**PLANNING COMMISSION
STAFF REPORT**

AGENDA ITEM: Planning File No. MAJ-24-0003: A sketch plan review of a multifamily/triplex residential development located at 909 Lakepoint Circle.

LOCATION: 909 Lakepoint Circle / LOT 16 BLOCK 3 LAKE POINT AT FRISCO SUB A RESUB PORTION L 2

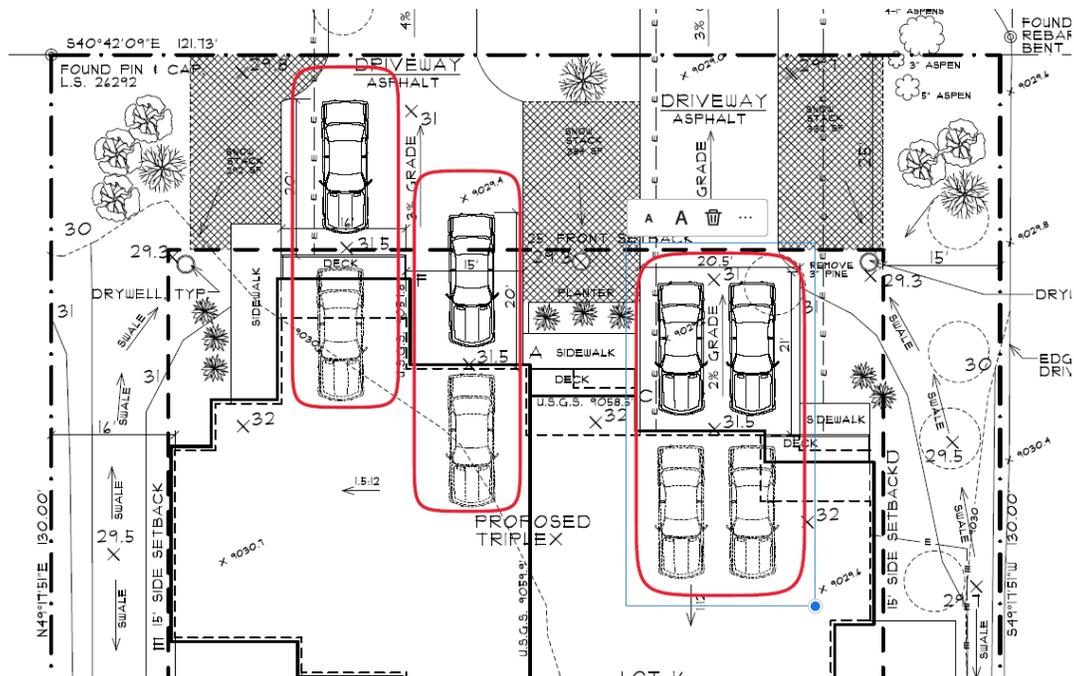
The Application shows driveways connecting to the ROW of Lakepoint Circle. This section of Lakepoint Circle is identified as an existing Frisco Pathway Route, which the Trails Master Plan identifies as remaining as a secondary connection. The public right-of-way serves as the pathway route, and no improvements are proposed or required for this pathway route. The Application is meeting these standards.
